ADDENDUM #1
BL106-24, Bryson Park Synthetic Turf Replacement

QUESTIONS & ANSWERS:

ATTACHMENT A

ORIGINAL GOALPAK® FOOTBALL / ROUND SOCCER GOAL SYSTEM, GROUND SLEEVE MOUNTED

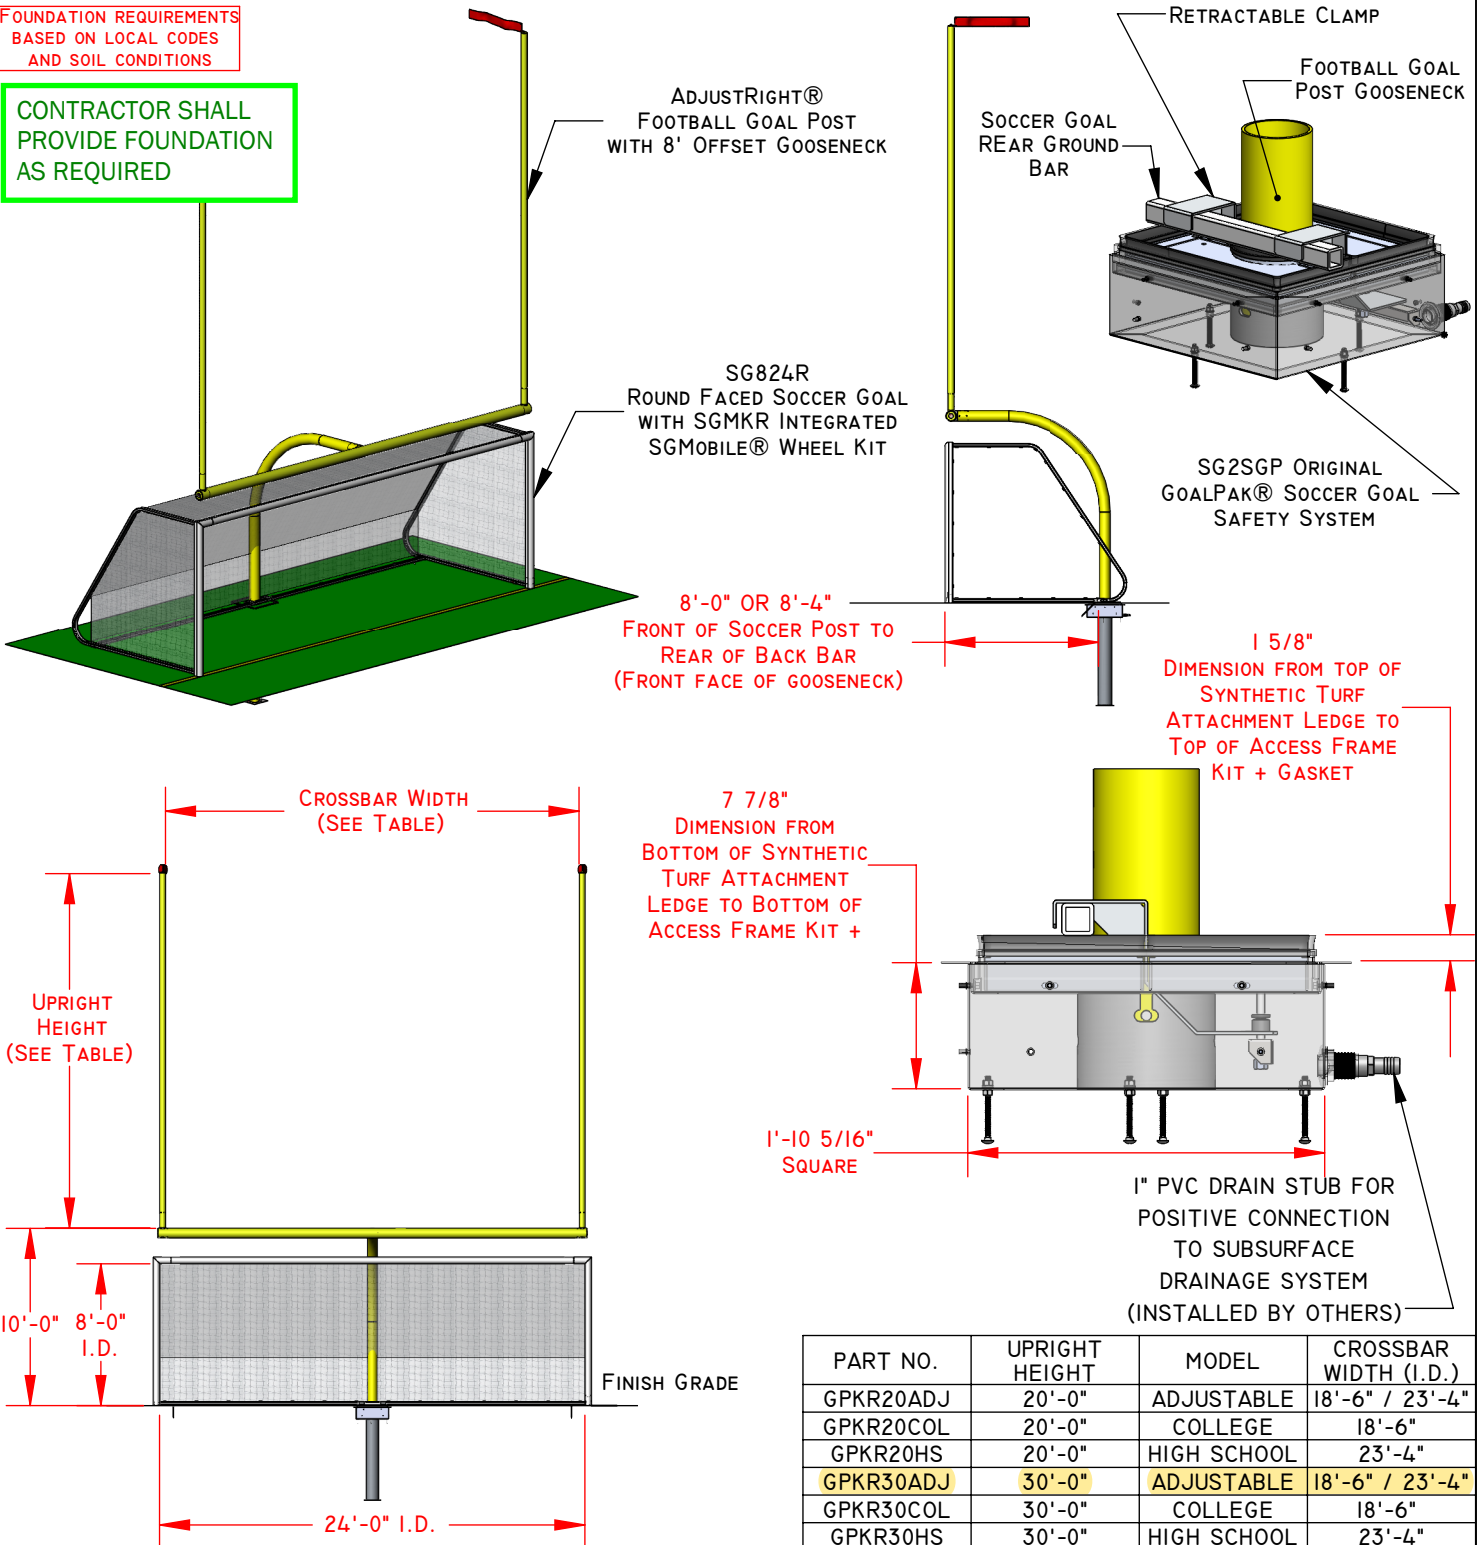
- Q6. On C300, there are 3 different call outs for the combination football/soccer goal – please clarify which of the indicated equipment specifications is correct.**
A6. The specified product is part number GPKR30ADJ. Please see Attachment A (Goal System Specification) for additional information.

Note: Gwinnett County wishes to utilize this ground sleeve mount instead of the plate mount
